## **Blast Management Strategy**

CHBPW-FGJV-NWW-EN-STG-000001- Revision D - Coffs  
Harbour Bypass

<b>Document Title</b>	Construction Blast Management Strategy
<b>Project Name</b>	Coffs Harbour Bypass
<b>Client</b>	Transport for New South Wales
<b>Application No.</b>	SSI-7666
<b>Document Reference No.</b>	CHBPW-FGJV-NWW-EN-STG-000001
<b>Principal Contractor</b>	Ferrovial Gamuda Joint Venture

Revision	Date	Description	Approval
A	March 2023	Draft for suitably qualified and experienced person review	
B	March 2023	Update in response to qualified and experienced person review	
C	April 2023	Update in response to TfNSW, ER, AA and EPA review	03/05/3023
D	June 2023	Update in response to DPE review

Proposed Controlled Blast Locations

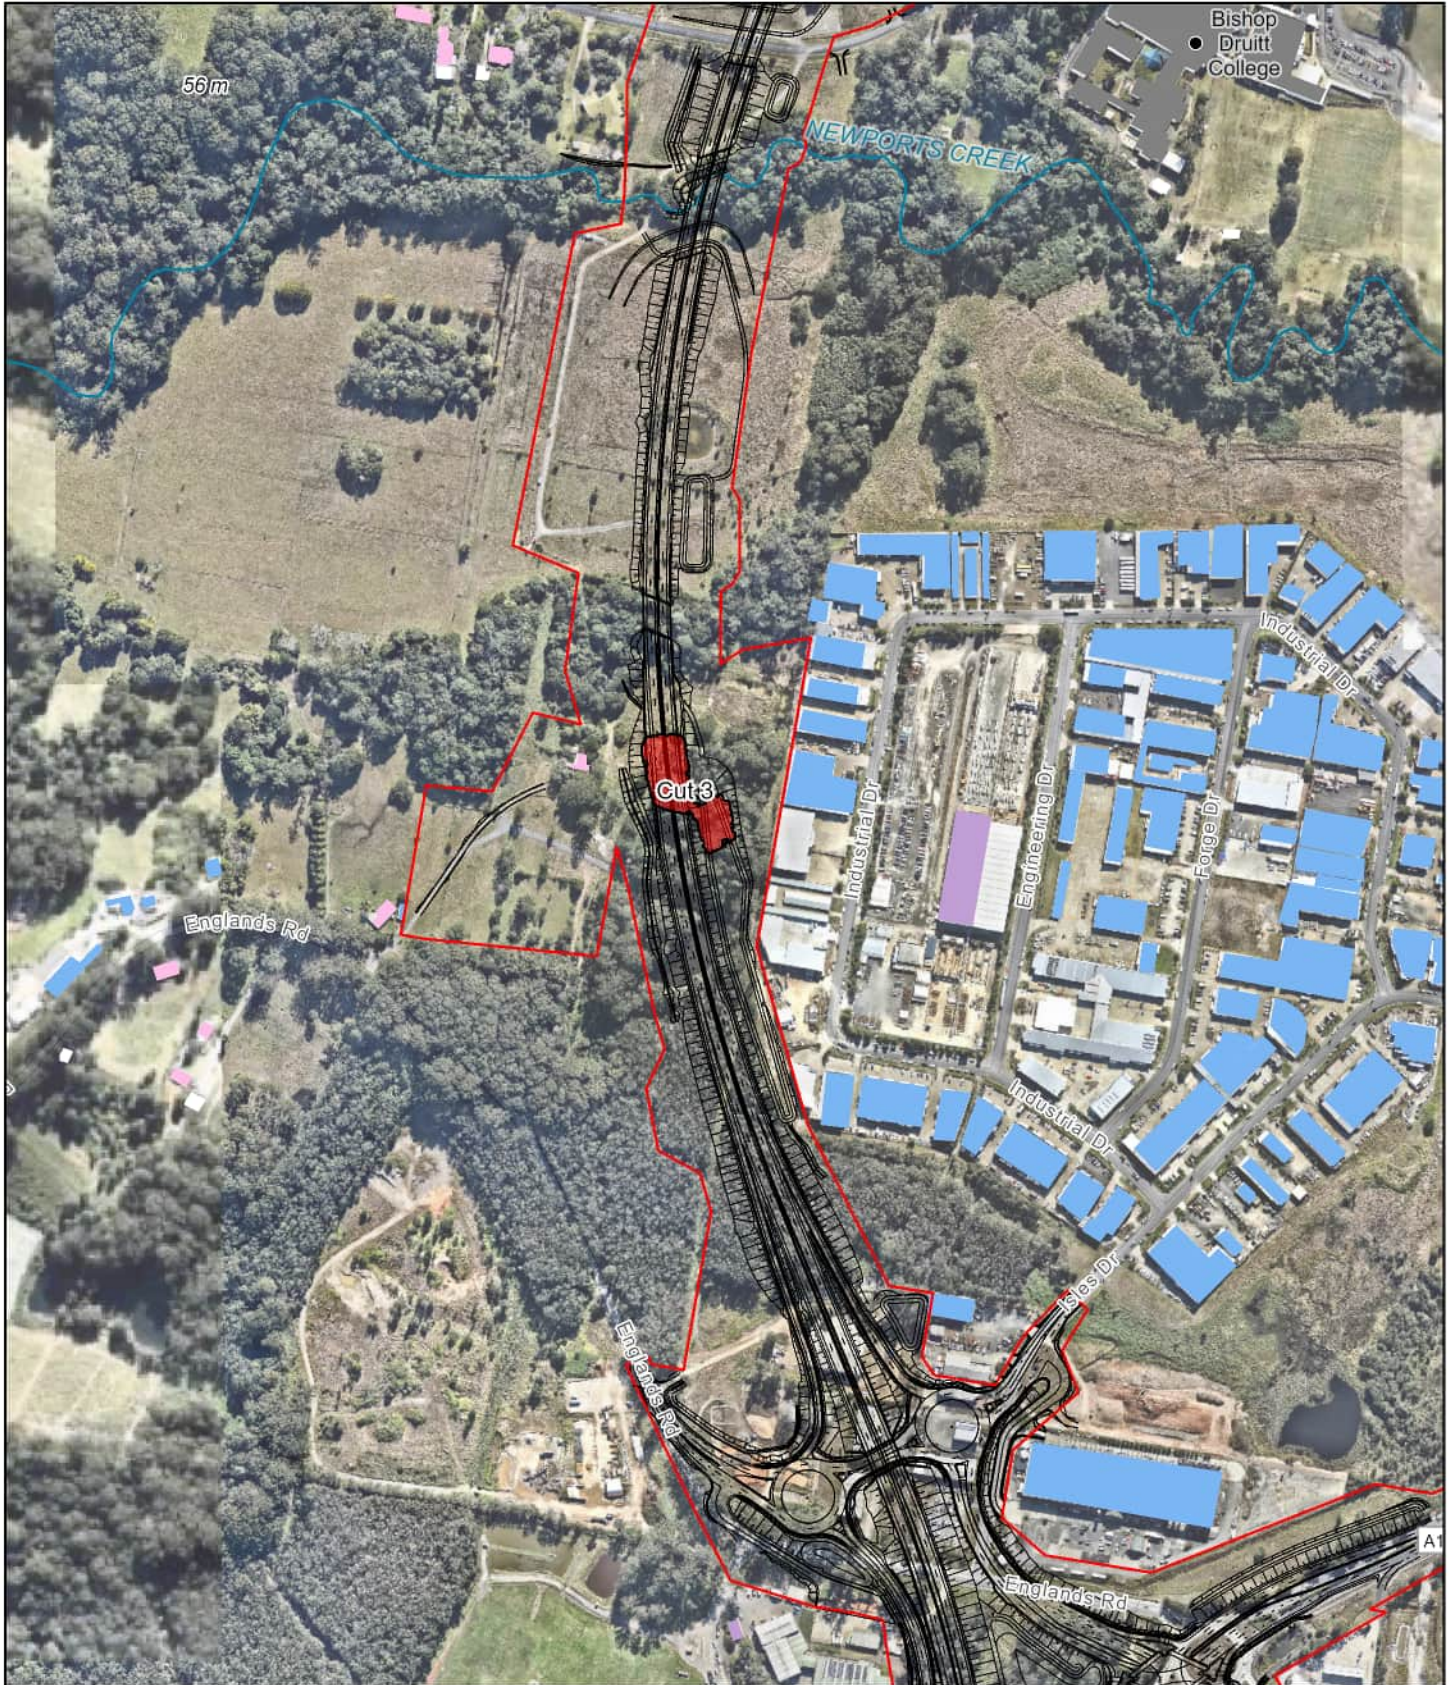
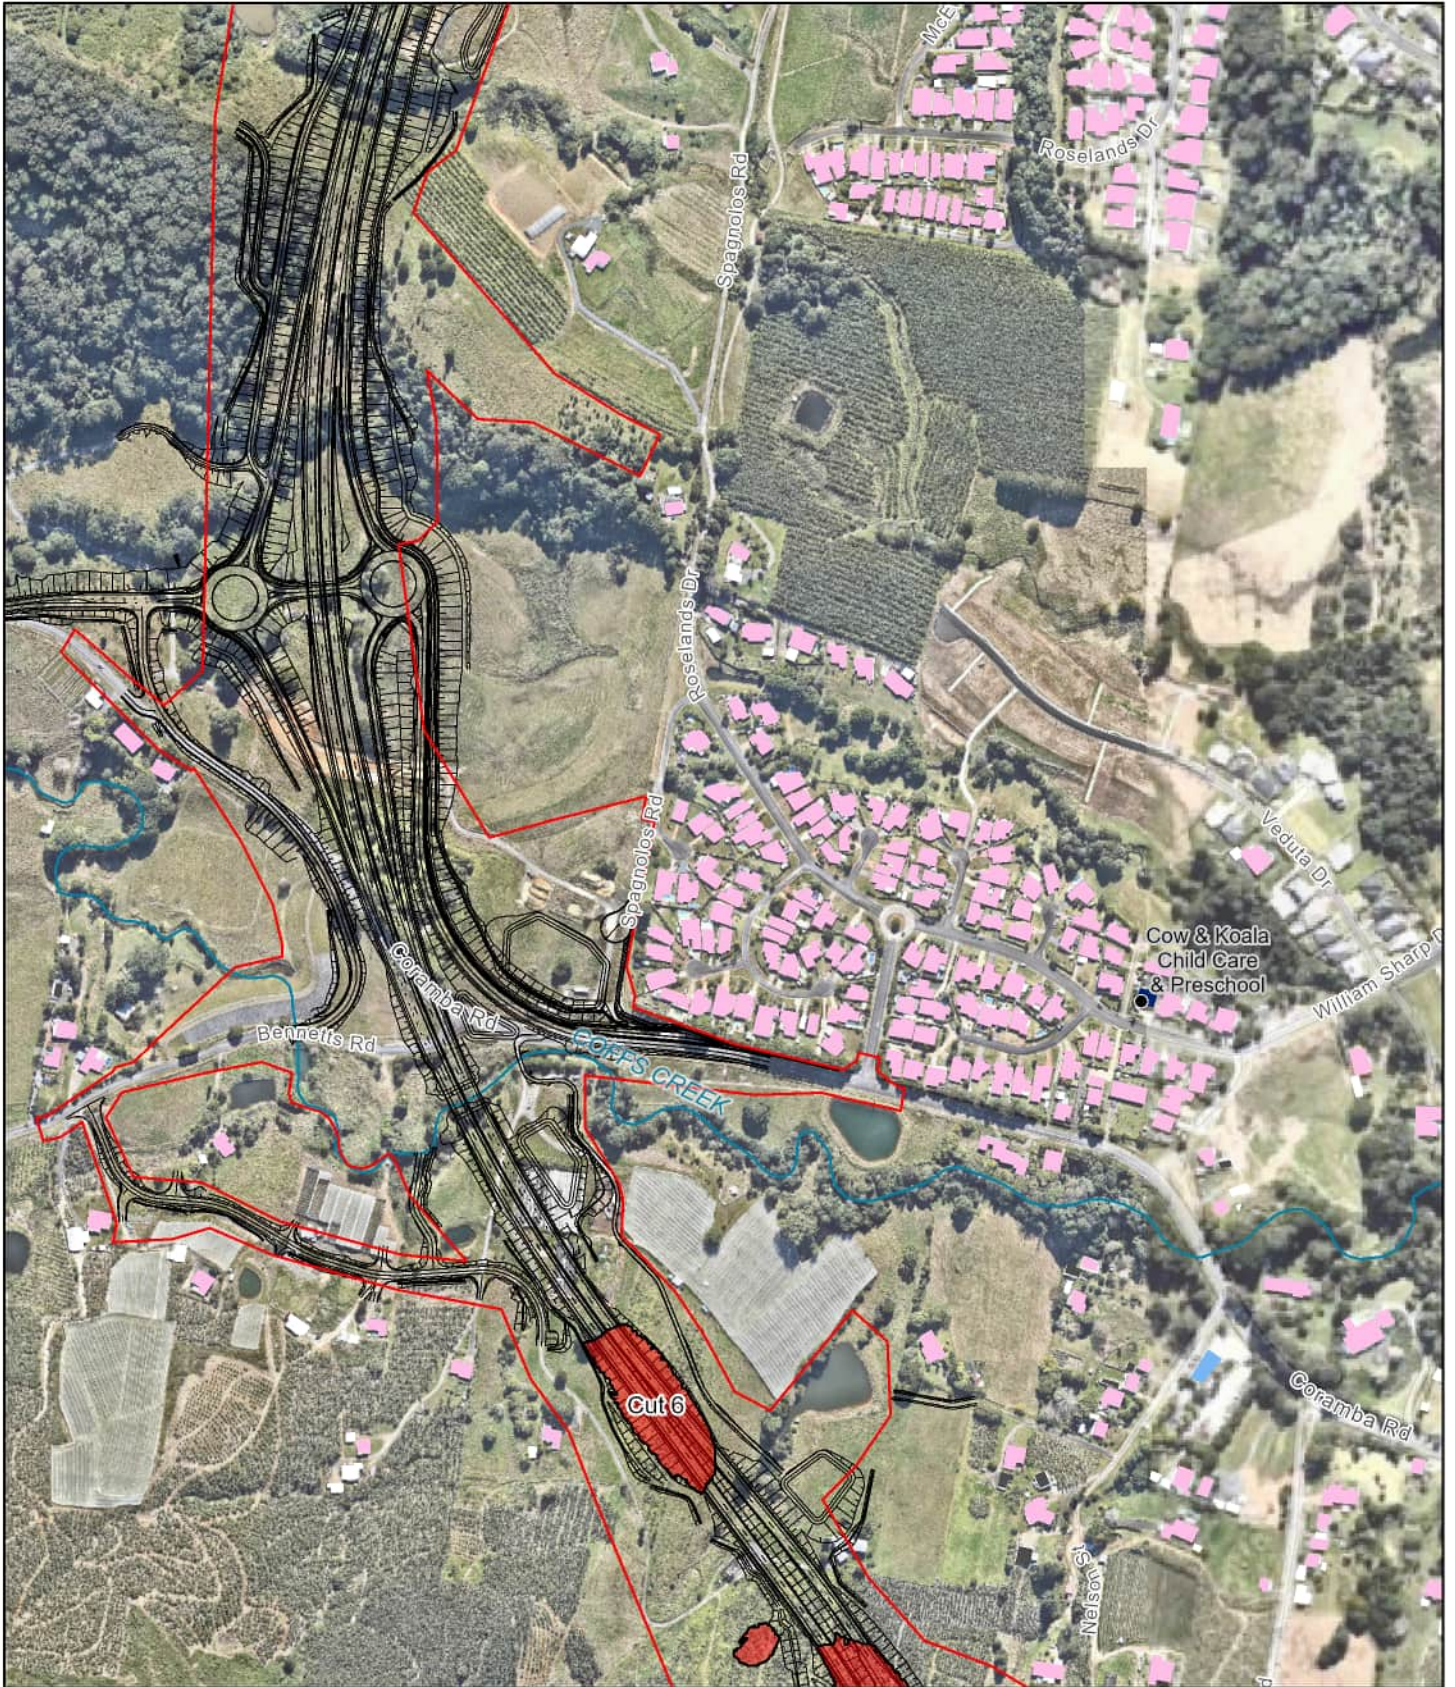
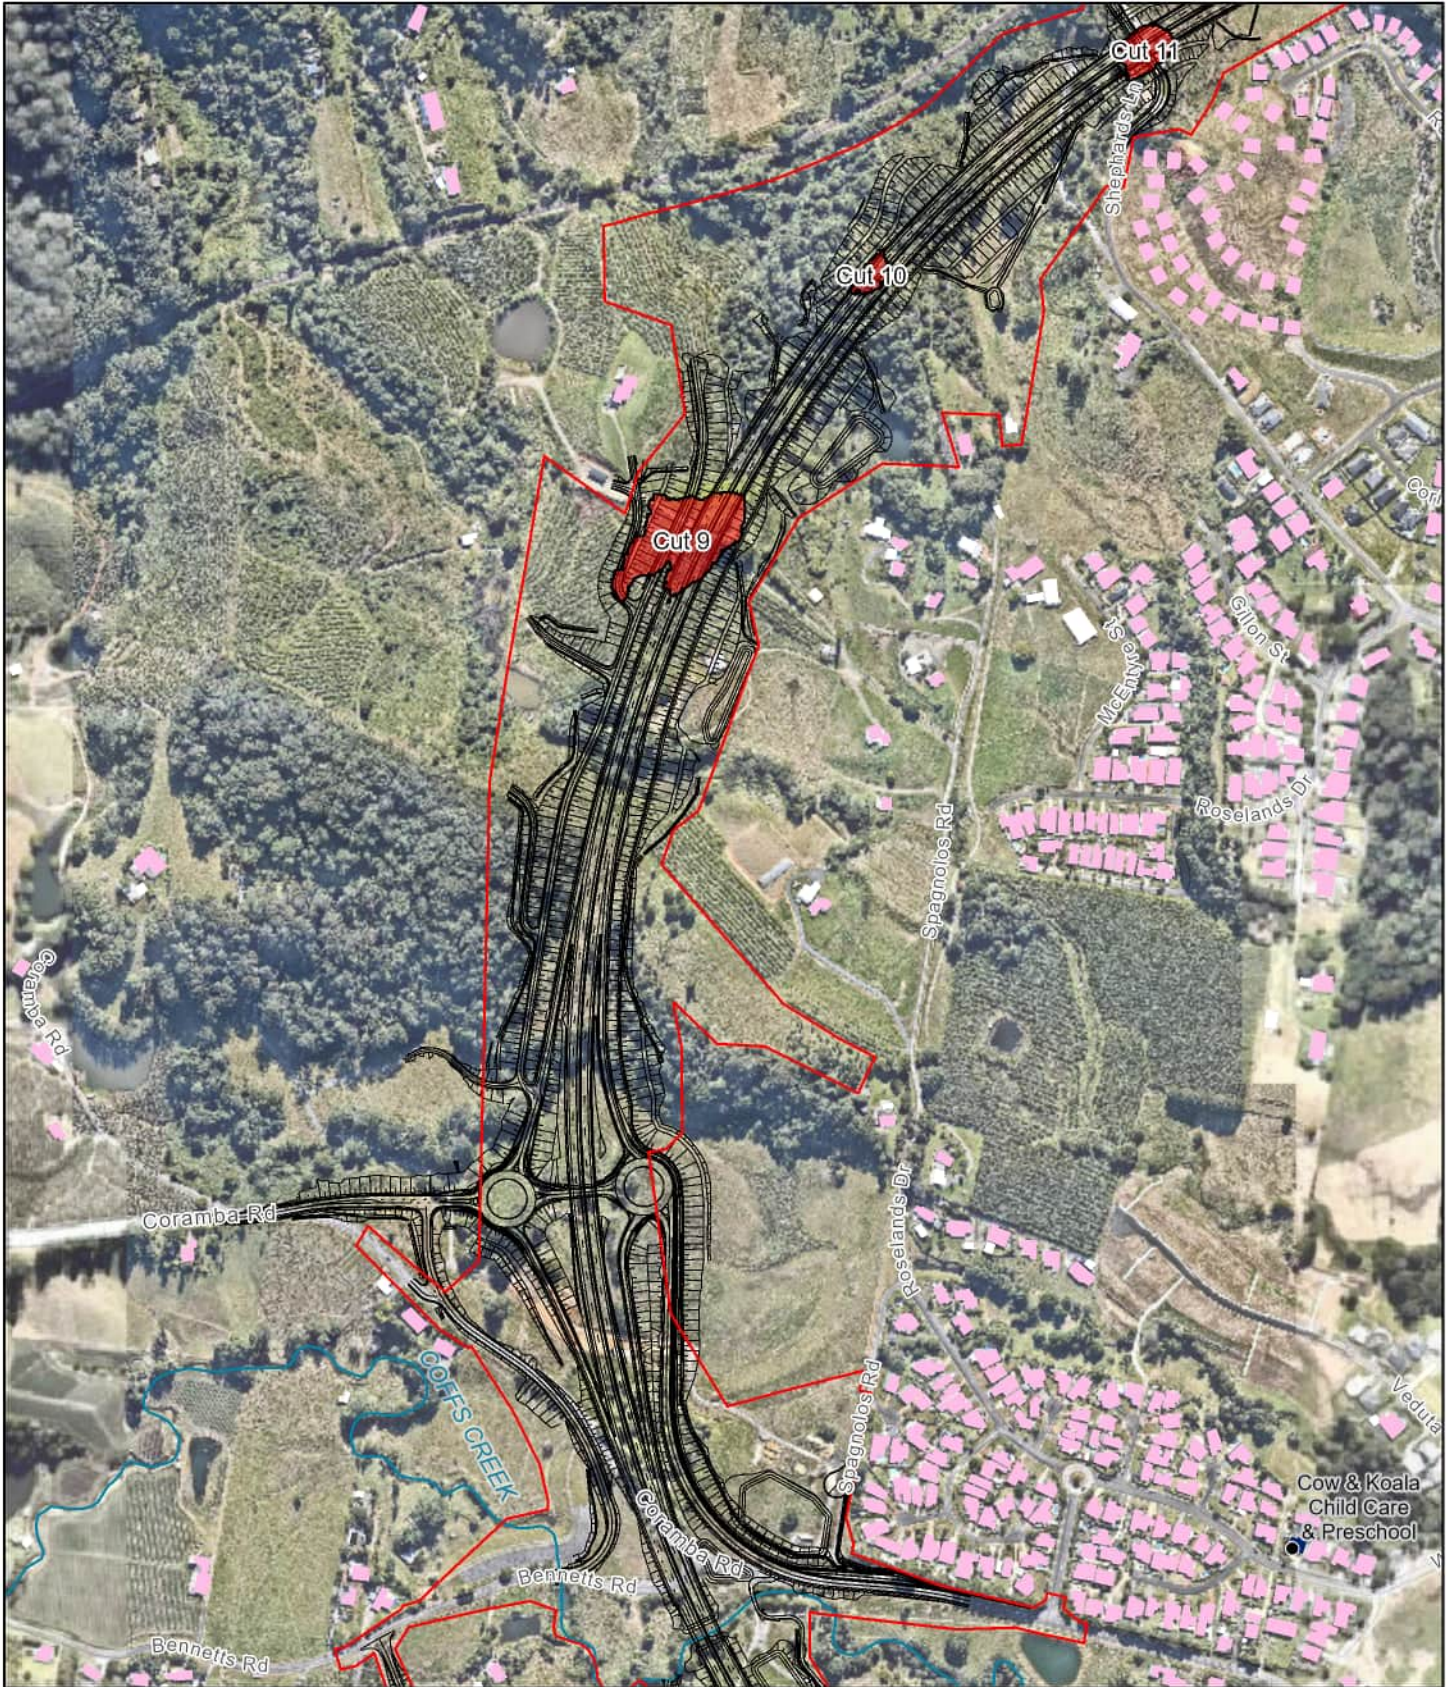
2	29/03/2023	B	ER	GeoLINK	Appendix 3		While the maps in Appendix 3 are clear with high resolution aerial photos, there is no way to cross reference with the locations listed in Table 3. Please provide 'cut/tunnel' labels and/or chainages on the maps.		Maps updated with labels detailing cut numbers and tunnel names.	Y				
3	29/03/2023	B	ER	GeoLINK	Sections 3.1 & 3.3	MCOA E59(b)	The document states that blasting may occur up to 4 times per day in tunnels and 2 times per day in cuttings, and that blasting will start about Sept 2023 and continue for approx. 24 months. More detail should be provided. E.g. is this regularity the same at all blasting locations? Will the stated blasting rates be continuous or intermittent throughout the 24 months? What is the duration of blasting at different locations? This is related to comment #5 below regarding the lack of a blasting program.		Indicative number of blasts and program included in Section 3.2 (Table 4).	Y
